**1034 MCGARRY TERRACE**  
Urban Design Review Panel Report

**Reference: 1034 McGarry Terrace Response to UDRP Planning Recommendations**

**1034 McGarry Terrace | Informal Pre-Consultation | Official Plan Amendment & Zoning By-law Amendment Application | Stantec Consulting Ltd., Progressive Architects Ltd.**

## PRIVATELY OWNED PUBLIC SPACE

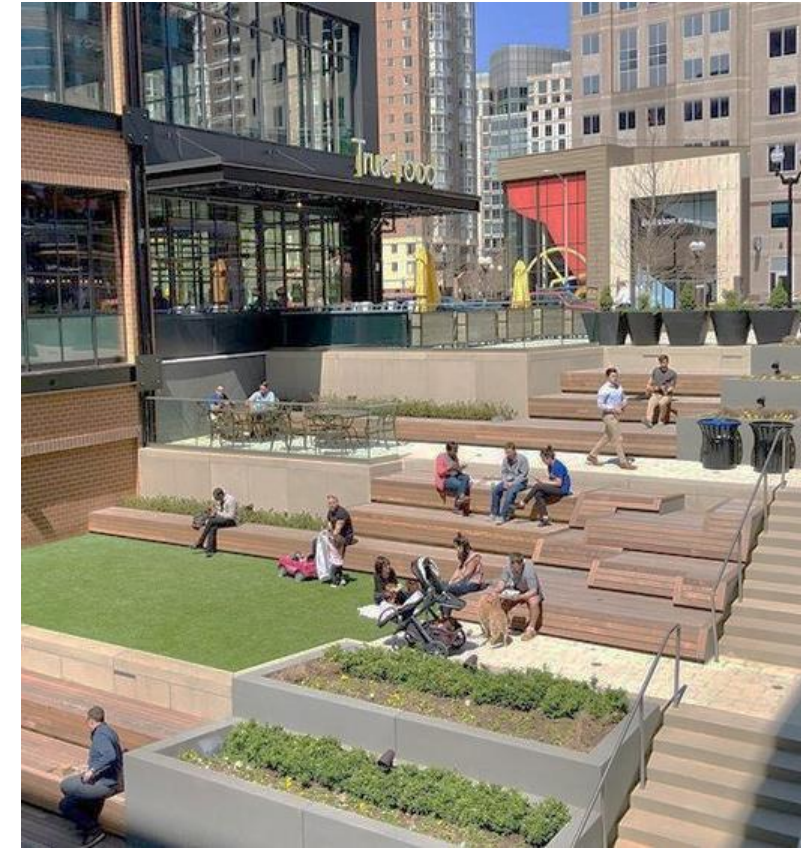
- The Panel appreciates the location of the POPS on the site
  - Consider including animated uses in the POPS including seating and benches.
  - Consider bolstering the POPS function and appearance as a forecourt for the greater community.

- Consider enlarging the POPS along Marketplace Avenue.
- The Panel recommends increasing the setbacks further from the property line.
- The Panel suggests the applicant undertake a wind study to ensure that the POPS has four-season pedestrian comfort.

- Consider the character of the streetscape and how the project contributes to establishing Marketplace Avenue as a Mainstreet.
  - As proposed, the POPS reads as a semi-private space, not a public space. The Panel recommends designing the POPS in a way that is more inviting to the public and passers-by. Consider how to best locate and design the POPS to take advantage of the Mainstreet and optimize public use.

- The Panel recommends designing a bigger POPS that would be more usable for local's leisure.
  - Consider designing one large central greenspace with more soft-scaping and large tree canopies.

- The Panel strongly recommends reconsidering the small tree beds proposed for the POPS.
    - Investigate creating public space with more soft-scaping and identifying ways to ensure the trees thrive to maturity with full-sized canopies.

The Panel appreciates the inclusion of the POPS on Marketplace Avenue; however, the Panel	A Landscape Strategy has been prepared which includes design of the courtyard POPS and

<p>recommends creating a larger POPS that strives to be a central public gathering space for the community.</p>	<p>abutting sidewalk space. The strategy proposes a continuation of the paving and street tree pattern of the development to the east while integrating seating, planting areas, and green groundcover areas. While the POPS area remains unchanged, the space now includes improvements to publicly owned space within the Marketplace right-of-way, and provides a continuous landscape approach across the entire frontage of the site. Further grading investigation has removed most stairs and retaining walls previously proposed.</p>
<p>The Panel recommends the public realm treatment of the proposed development be a more comprehensive and robust design proposal that considers pedestrian connectivity through the site and fosters a central gathering space for the future growth in the area.</p>	
<p><b>Site Design and Public Realm</b></p>
